UNITED STATES DEPARTMENT OF COMMERCE United States Patent and Trademark Office Address: COMMISSIONER FOR PATENTS P.O. Box 1450 Alexandria, Virginia 22313-1450 www.uspto.gov

APPLICATION NO.	FILING DATE	FIRST NAMED INVENTOR	ATTORNEY DOCKET NO.	CONFIRMATION NO.
10/707,914	01/23/2004	William Witherspoon	<b>04W</b> 1701	1913
24234 SIMMONS PEI	7590 03/18/200 RRINE PLC	EXAMINER		
THIRD FLOOF	R TOWER PLACE	SPINELLA, KEVIN		
22 SOUTH LINN STREET IOWA CITY, IA 52240			ART UNIT	PAPER NUMBER
			2885	
			MAIL DATE	DELIVERY MODE
			03/18/2008	PAPER

Application No.	Applicant(s)				
Office Action Comments	10/707,914	WITHERSPOON, WILLIAM				
Office Action Summary	Examiner	Art Unit				
	KEVIN SPINELLA	2885				
The MAILING DATE of this communication appears on the cover sheet with the correspondence address Period for Reply						
A SHORTENED STATUTORY PERIOD FOR REPLY IS SET TO EXPIRE 3 MONTH(S) OR THIRTY (30) DAYS, WHICHEVER IS LONGER, FROM THE MAILING DATE OF THIS COMMUNICATION.  - Extensions of time may be available under the provisions of 37 CFR 1.136(a). In no event, however, may a reply be timely filed after SIX (6) MONTHS from the mailing date of this communication.  - If NO period for reply

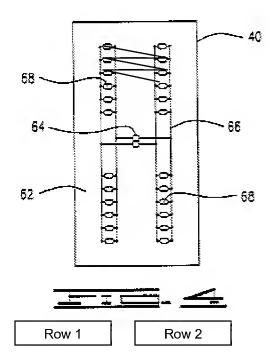
- 29. In regard to Claim 25, Nolan teaches the pattern of rows (Figure 4) positioned (Figure 4) so that the LEDs 68 create a grid (Figure 4) of perpendicular rows and columns (Figure 4).
- 30. In regard to Claim 26, Nolan teaches certain LEDs 68 in adjacent rows (Figure 4) are offset from each other (see attached Figure 4, diagonal space exists between the LEDs so that LEDs are offset from each other by a distance) and not in perpendicular alignment (see diagonal spacing lines in attached Figure 4) with the axes of the pattern of rows (Figure 4).
